R_{peak} specifications

(comments #143, #200, #232, #360)

IEEE P802.3dj Task Force, November 2025 (r3)

Figure 176D-8b—Module test channel calibration

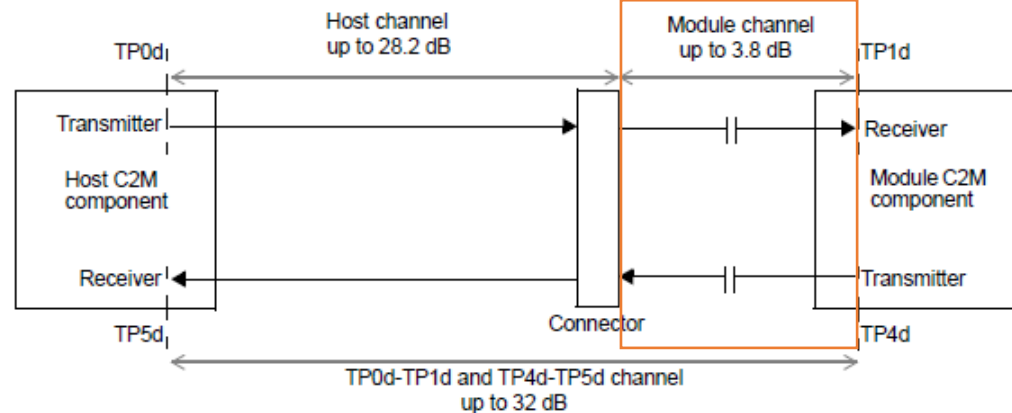
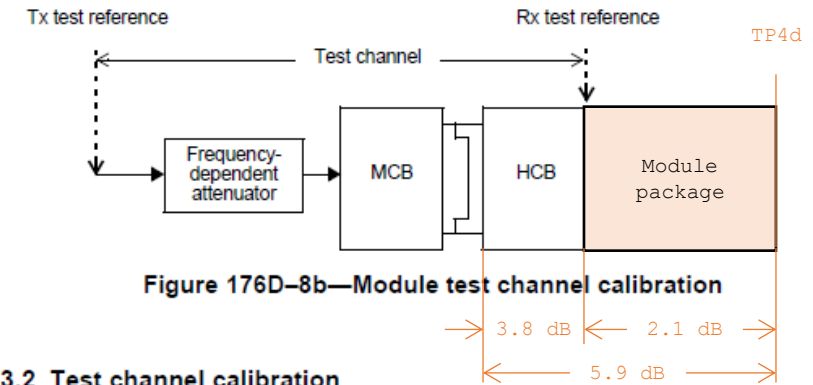
- COM reference model is used to calibrate the test channel for interference/jitter tolerance tests
- Assumes the module channel consists of HCB and a device package model
- This is inconsistent with the reference insertion loss budget illustrated in Figure 176D-6
- Assume module channel loss is consistent with the model used for test channel calibration

- There appears to be a discrepancy between the module reference insertion loss and the interference/jitter tolerance test channel calibration procedure

Simplification of test fixture reference insertion loss

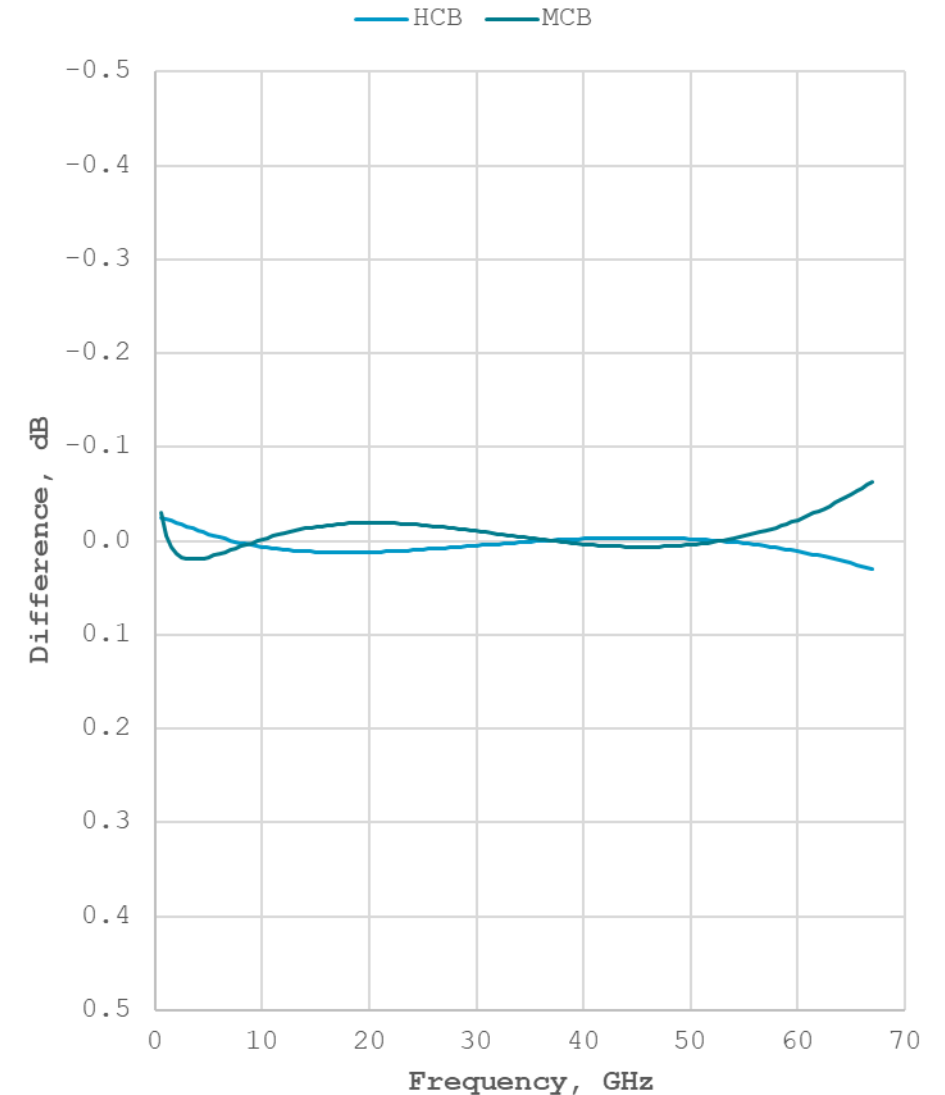
- Draft 2.2 specifies reference insertion loss using an equation with the form shown above
- These equations include a $f^{1.5}$ term and negative polynomial coefficients
- The $f^{1.5}$ term can be removed and coefficients constrained to positive values
- The resulting equations are practically identical to the originals and are more amenable to a physical interpretation
- It is straightforward to determine a causal phase from the re-fit equations for use in time-domain modeling

- It was shown that the reference insertion loss polynomials could be simplified with no meaningful change to the loss values
- These simplifications should be considered for the next draft

Results with loss budgets modified per comment #232

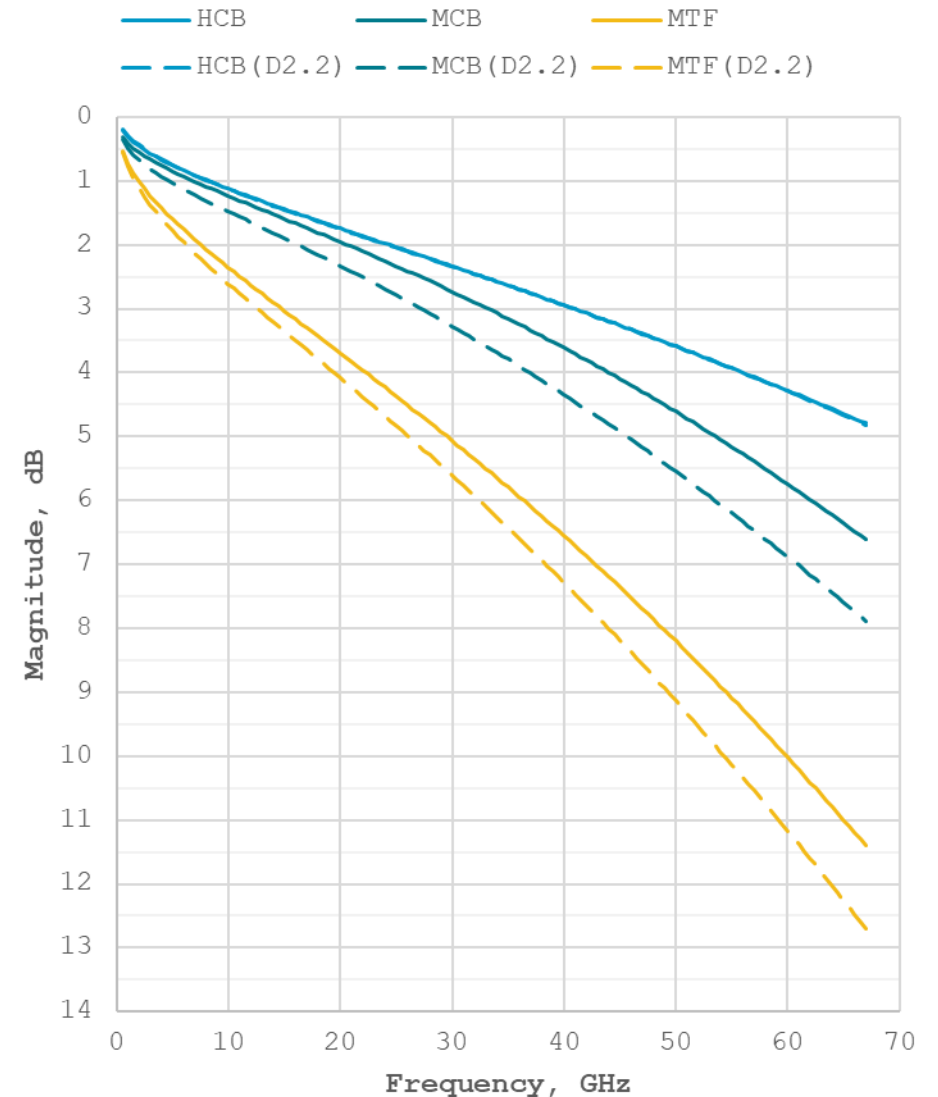
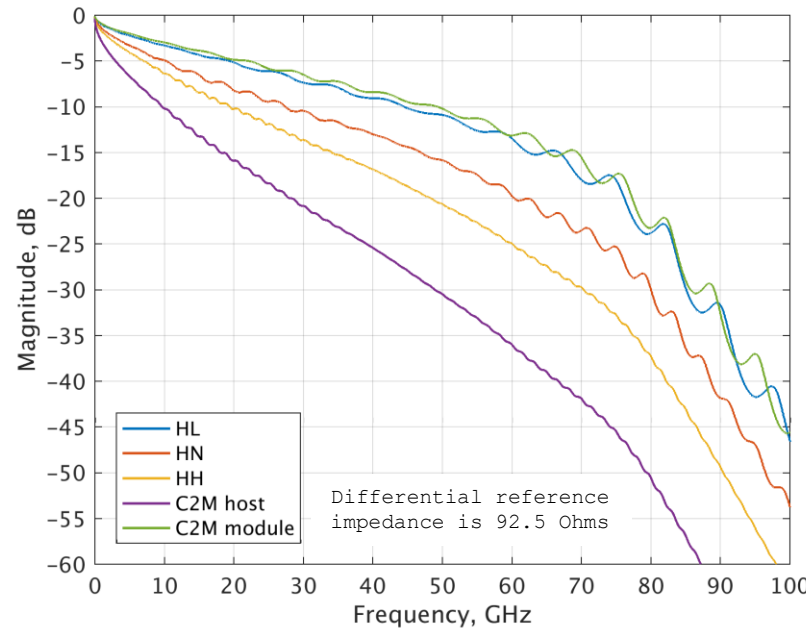
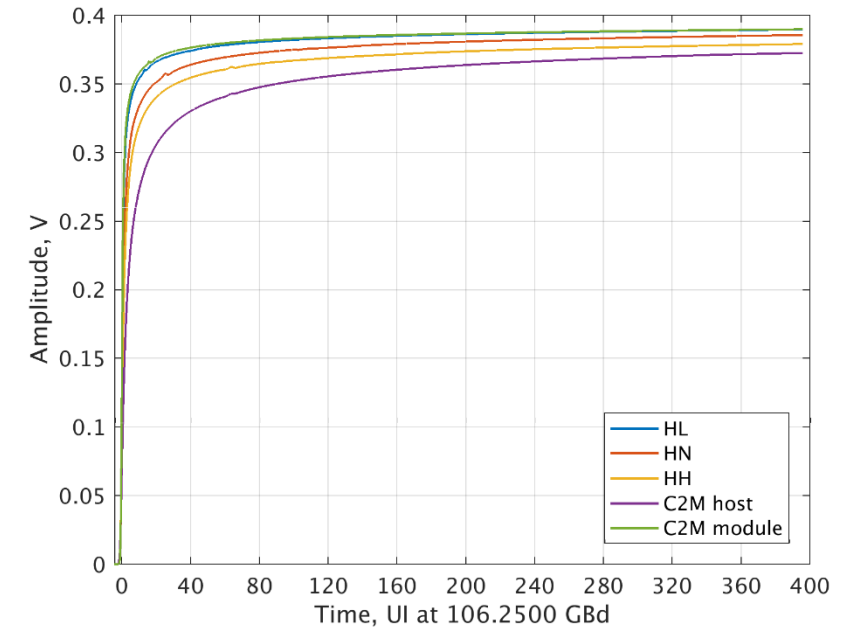
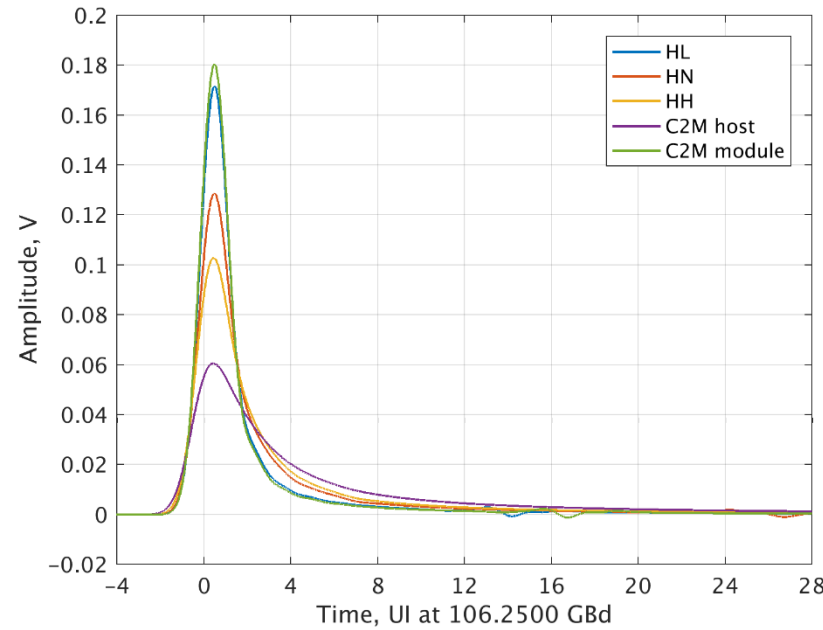
- Comment #232 suggests a reallocation of the loss budget to account for reductions to connector (and via) loss
- It proposes to reduce the cable assembly test fixture (MCB) and Clause 179 host loss allocations by 1 dB
- A new cable assembly test fixture reference insertion loss is defined by scaling the original equation
- The mated test fixture reference insertion loss is still the sum of the individual test fixture reference insertion losses
